## **Report on submissions relating to Plan Change 2**

**Rezoning Rural (Inner Plains) land to Living XA (Deferred)  
Blakes and Trents Roads, Prebbleton**

**Report Number:**  
**To:**  
**From:**  
**Hearing Date:**

PC 080002  
Hearing Commissioner – K Gimblett  
Policy Planner – C Friedel  
28<sup>th</sup> and 29<sup>th</sup> July 2010

**Housing Density**

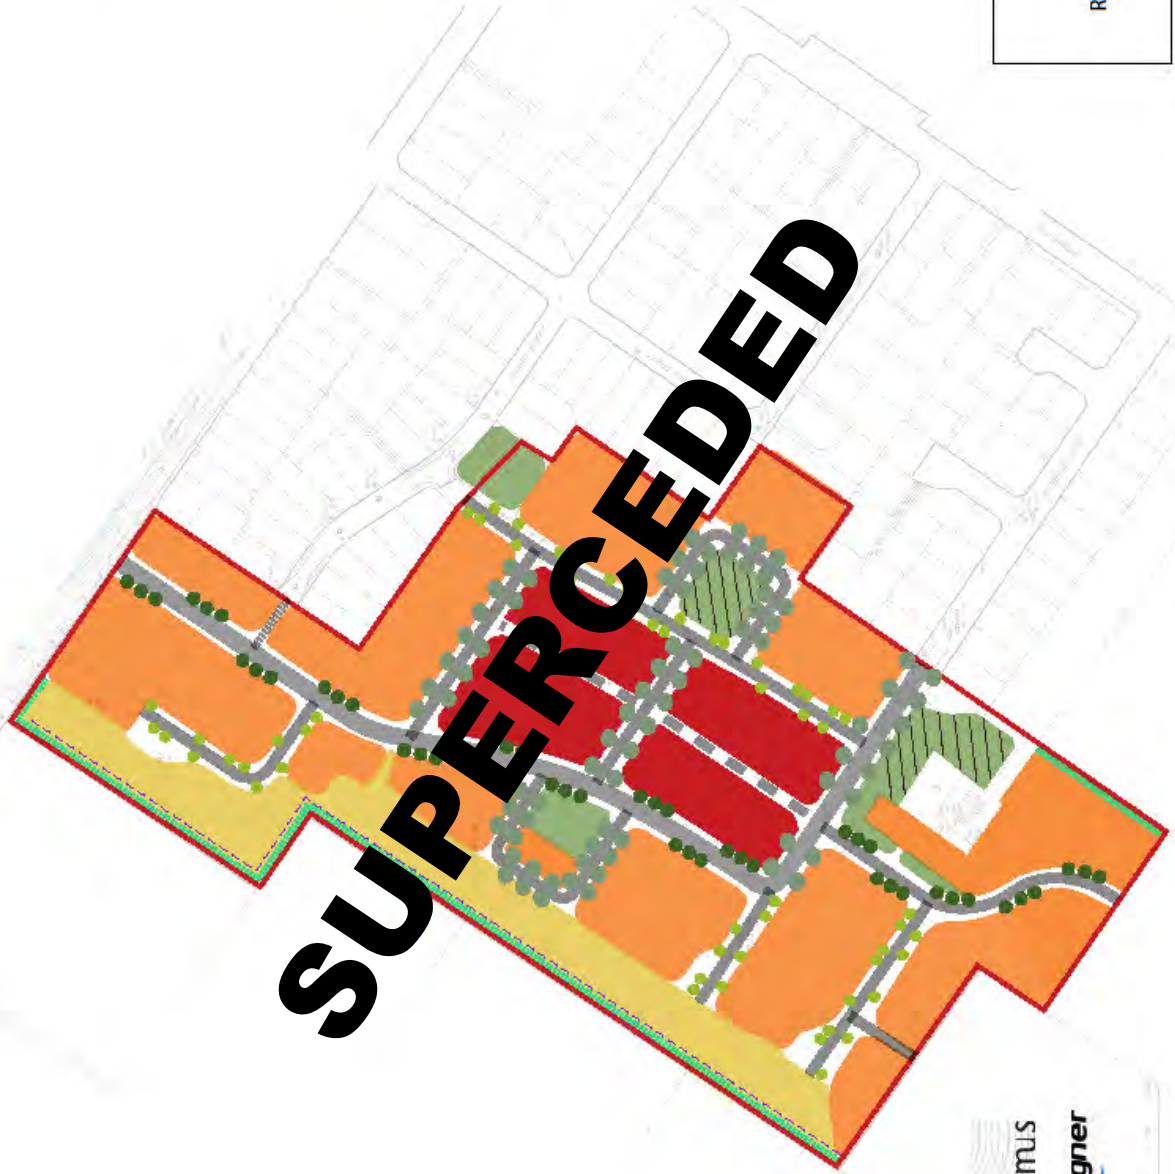
- ☐ A decrease in the housing densities proposed for Area C from 400m<sup>2</sup> to 600m<sup>2</sup> to 450m<sup>2</sup> minimum lot sizes and an average minimum lot size of 550m<sup>2</sup>. This change has been promoted to address concerns raised in submissions and to avoid uncertainty or inconsistency with PC7; and
- ☐ An extension of the more standardised residential section sizes contained in Area B to replace the low density sections along the border of the PC1 'Greenfield' land directly to the south. This change has been promoted to align PC2 with the PSP and decisions released on PC1, which has identified the land directly to the south as a future residential 'Greenfield' area.

- 5.10 It is for the above reasons that I support the increased densities along the interface between the PC1 'Greenfield' land to the south and the subject property in principle, but believe that such a change is beyond the scope of the relief sought by the submissions received on PC2 [**Section 8 – Amendment 2**].

**Figure 4. Preliminary outline development plan SP1, SP4 and Meadow Mushrooms\***

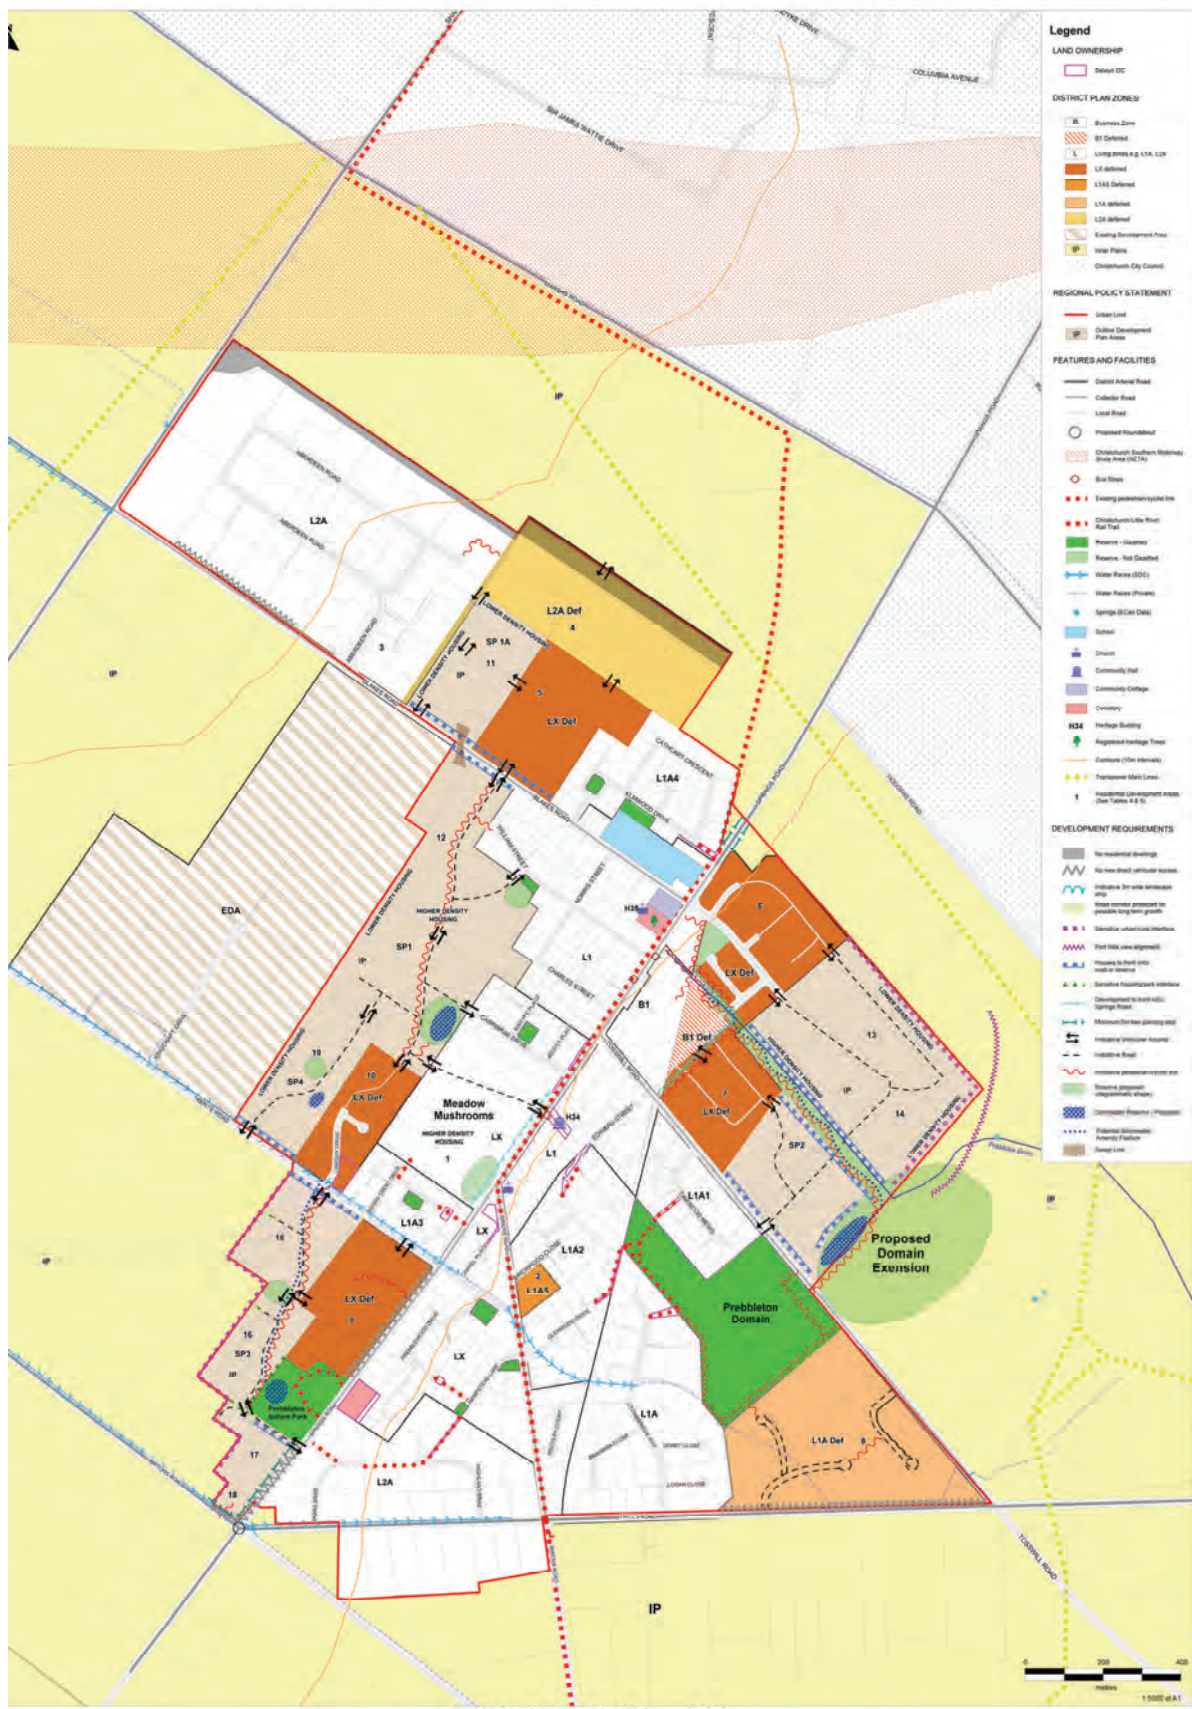
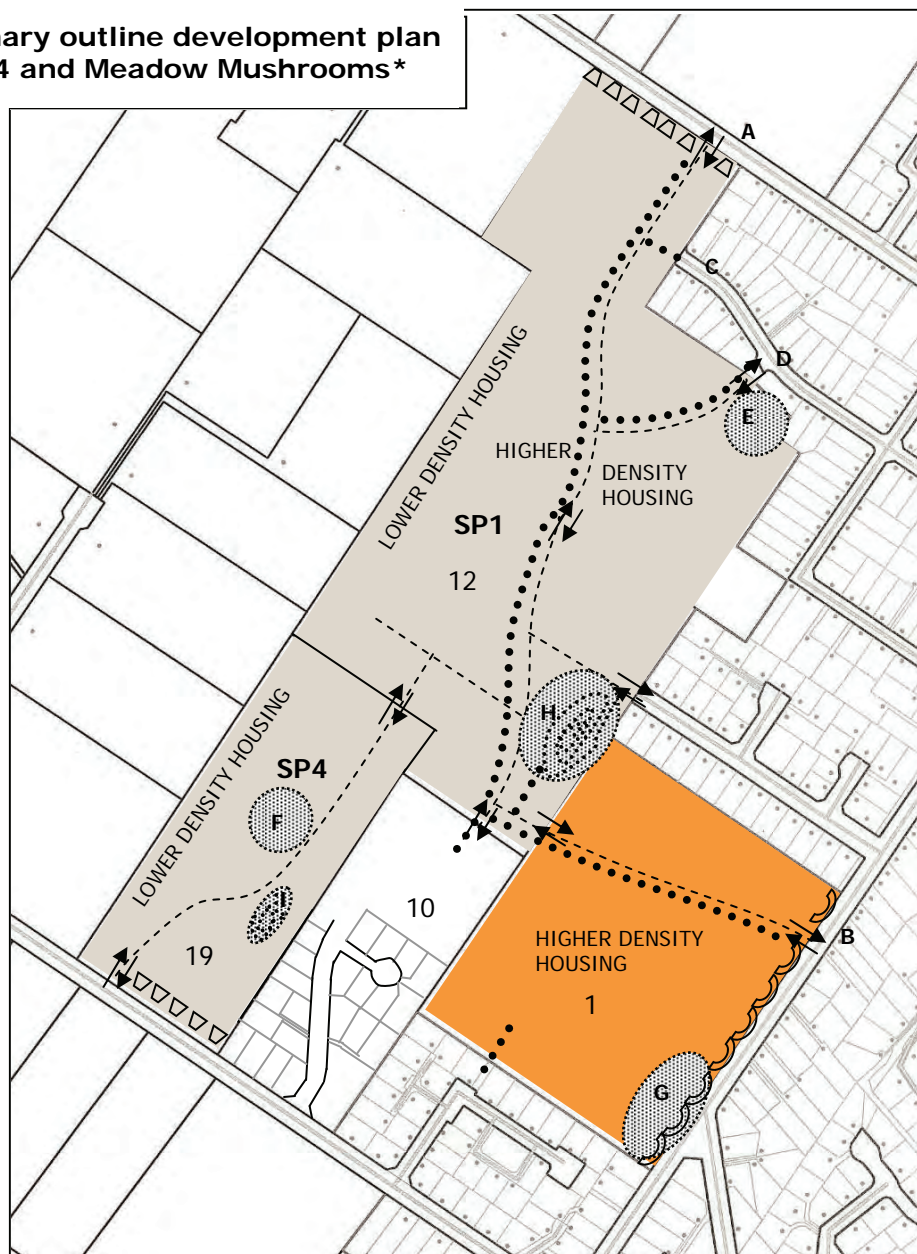
- 5.93 A preliminary ODP has been incorporated into the PSP that identifies the anticipated road network linking the subject land with the Meadow Mushrooms site and Springs Road to the east (see **Attachment D**). This ODP seeks to promote connectivity between the village core to the western outskirts of the township, which includes the residential housing, reserves and destinations either within or in close proximity to the subject land. The ability to provide these possible future connections will be lost if they are not recognised in PC2. Mr Owen verifies the need for an additional road connection linking the subject land to the Meadow Mushrooms site to the east. The applicant has now provided this additional linkage to address the relief sought in submissions (see **Attachment B**).

- 5.96 A preliminary ODP has been incorporated into the PSP that included the anticipated road network linking the subject land with the SP4 'Greenfield' land to the south (see **Attachment D**). This ODP seeks to promote connectivity between the village core to the western outskirts of the township, which includes the residential housing, reserves and destinations either within or in close proximity to the subject land. The ability to provide these possible future connections will be lost if they are not recognised in PC2. Mr Owen verifies the need for additional road connections linking the subject land to the 'Greenfield' land to the south.
